ADDENDUM 1 TO BID #AZA 101103

PARTIAL MODERNIZATION

JAMES MADISON ELEMENTARY SCHOOL
1510 S. Nutwood Street, Anaheim, CA 92804

ADDENDUM 1 – James Madison ES Modernization

SK-10 Item 20a Revised layout P6.1

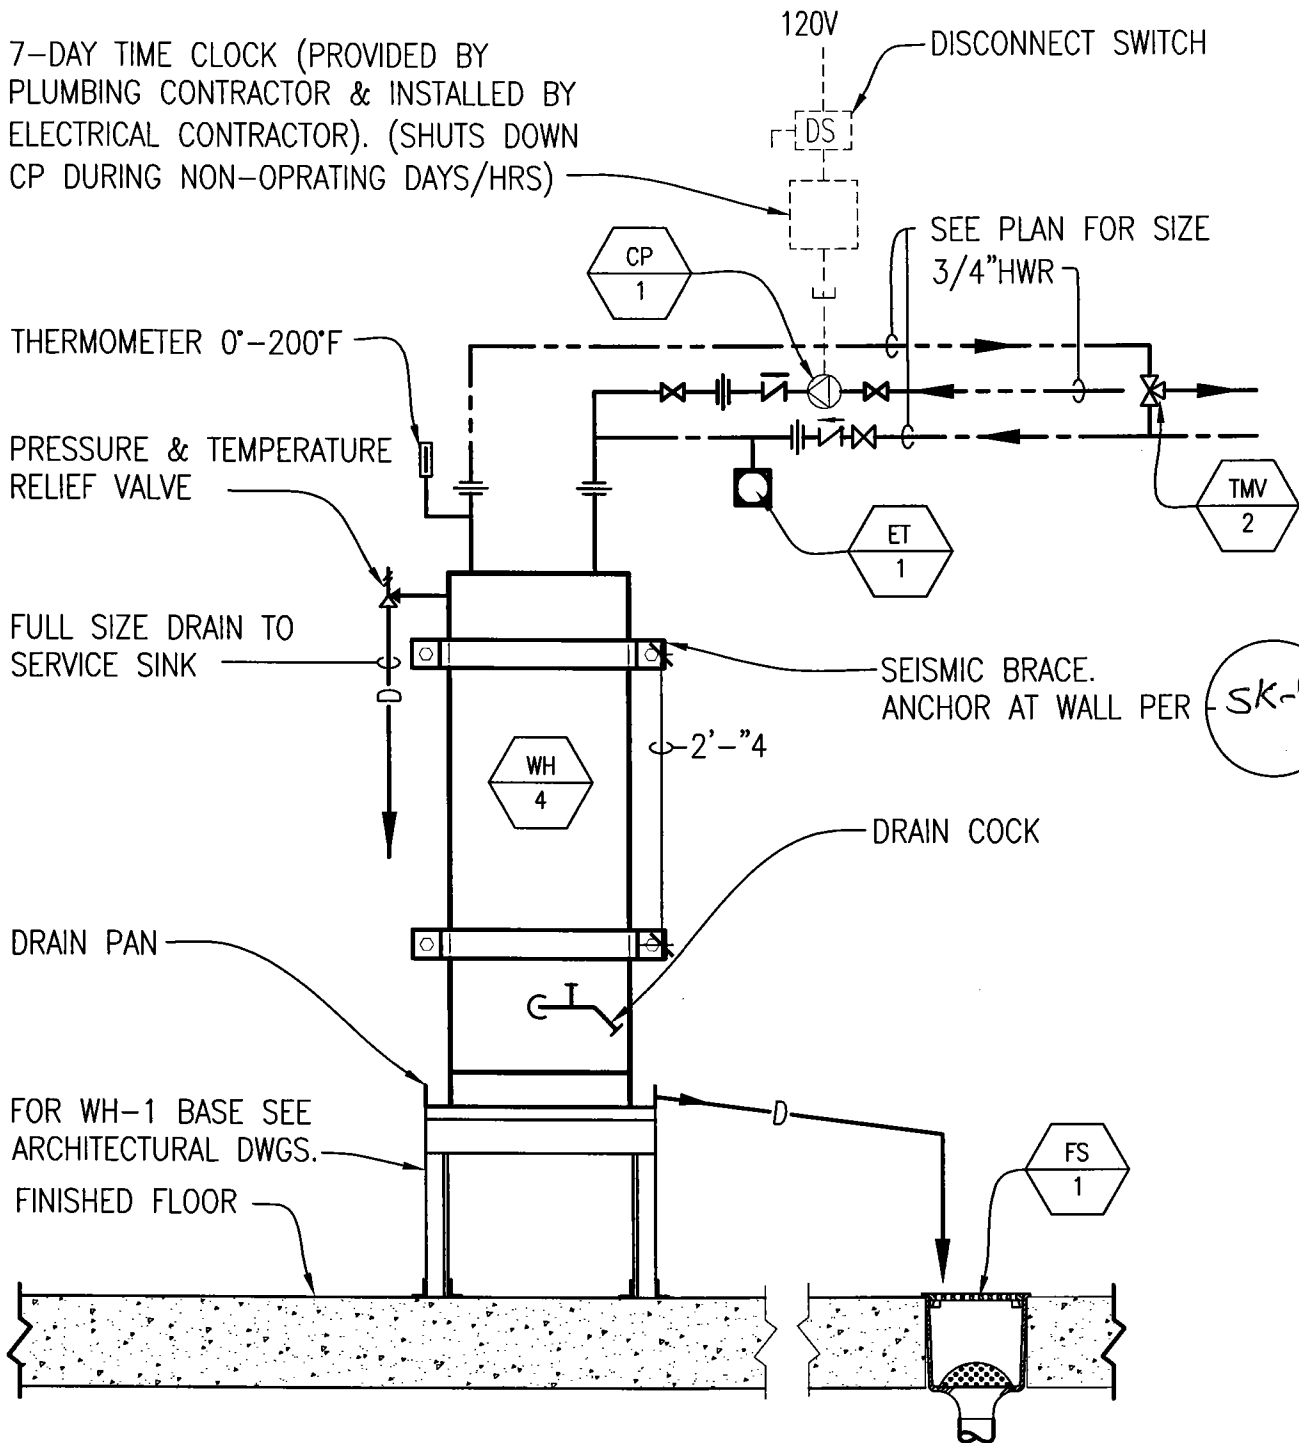
- a. Plan #1 – New hot water line added (See SK-10)
21. Sheets P7.2 Plumbing Details
 - a. Detail #3 – Detail added (See SK-11)
22. Sheets M1.3 Floor Plans – Buildings ‘D’, ‘E’, & ‘I’

55 3/4" HWR.
 56 BALANCING VALVE.
